Attachment 1. Assessment against Clause 15.4.1 (P1)

15.4.1 Building height, setback and siting

89-93 Cimitiere Street and 34 Cameron Street, Launceston - 2 December 2021

Fig. 3 Cimitiere Street - East of Tamar St

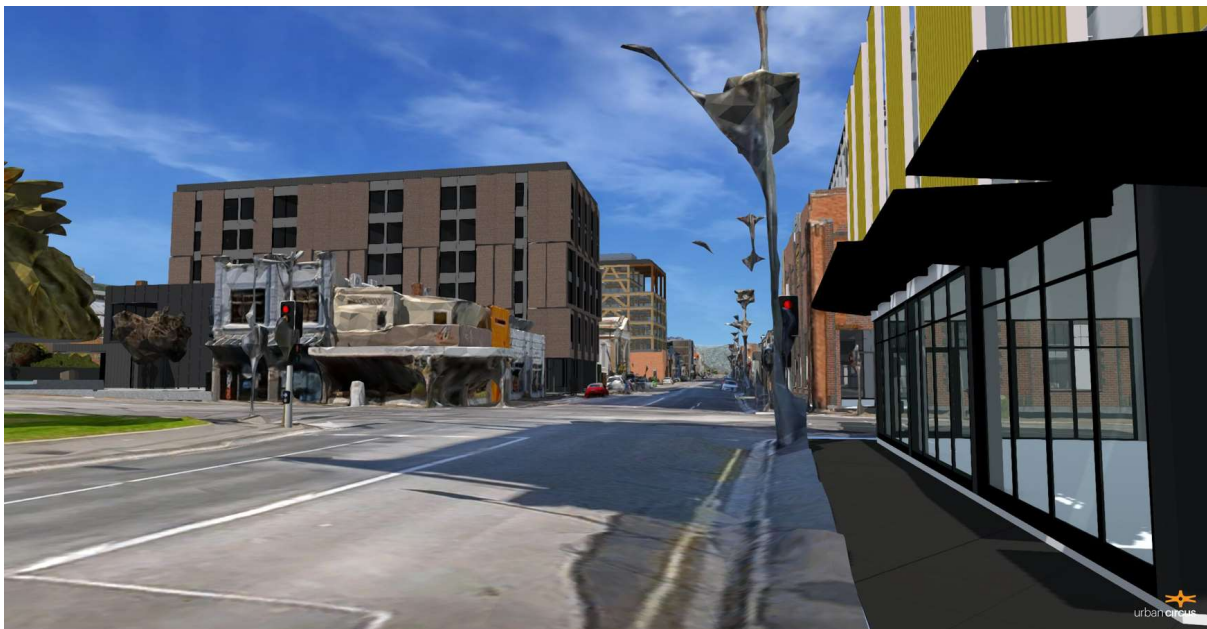
The height of the proposed building is most apparent from the northern footpath. Coming from the east, the majority of views of the proposal are obstructed by the Verge Hotel, passing Tamar St the proposal is more visible but continues to sit comfortably within the existing line of buildings in the streetscape.

Fig. 18 Tamar St & Boland St

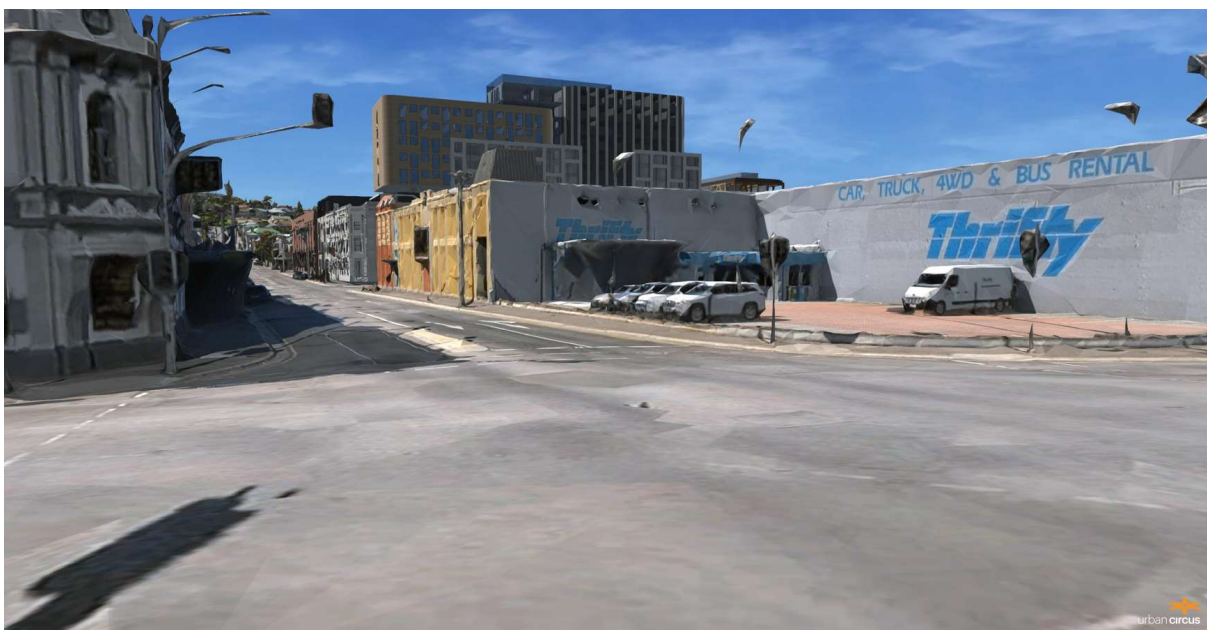
Very limited views of the roof of the proposed building are available in the wider streetscape of the precinct when seen from the intersection of Boland St and Tamar St. Following Tamar St to the south, the proposal is completely concealed except for some partial views at Tamar St & Elphin Road. The views from this intersection also constitute the views available from City Park as a public place. As seen in the images below, the apparent height of the proposal will have a negligible impact on the streetscape and character of the surrounding area when seen from Tamar St and City Park.
